World Forum for Harmonization of Vehicle Regulations

Proposal for Supplement 6 to the 03 series of amendments to Regulation No. 129 (Enhanced Child Restraint Systems)

Submitted by the Working Party on Passive Safety *

Figure 6
Minimum distance for lateral impact

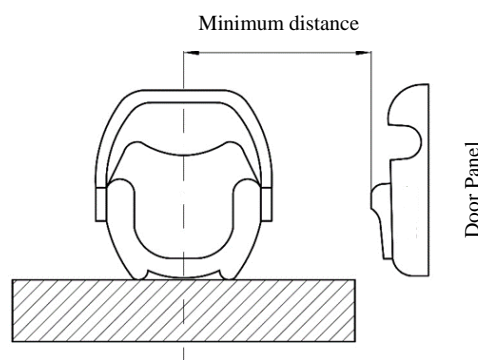
Paragraph 7.1.3., amend to read:

For each test, the initial position of the side impact door panel relative to the bench shall be adjusted according to the minimum distance between the vehicle's door panel and the centre of the seating position as shown in Figure 6.

"7.1.3. Dynamic Testing for Frontal, Rear and Lateral Impact:

- (e) For lateral impacts tests the Enhanced Child Restraint Systems shall be tested in its most upright used position. If this upright position falls outside the Vehicle Seat Fixture, this position shall still be chosen.

For Enhanced Child Restraint Systems that fit into any of the vehicle seat fixtures where the lateral shock absorbers can be adjusted outside the Vehicle Seat Fixture, the width position of the lateral shock absorbers that still fit in the Vehicle Seat Fixture shall be chosen;

For Enhanced Child Restraint Systems that do not fit into any of the vehicle seat fixtures, a lateral test shall be performed for each listed vehicle.
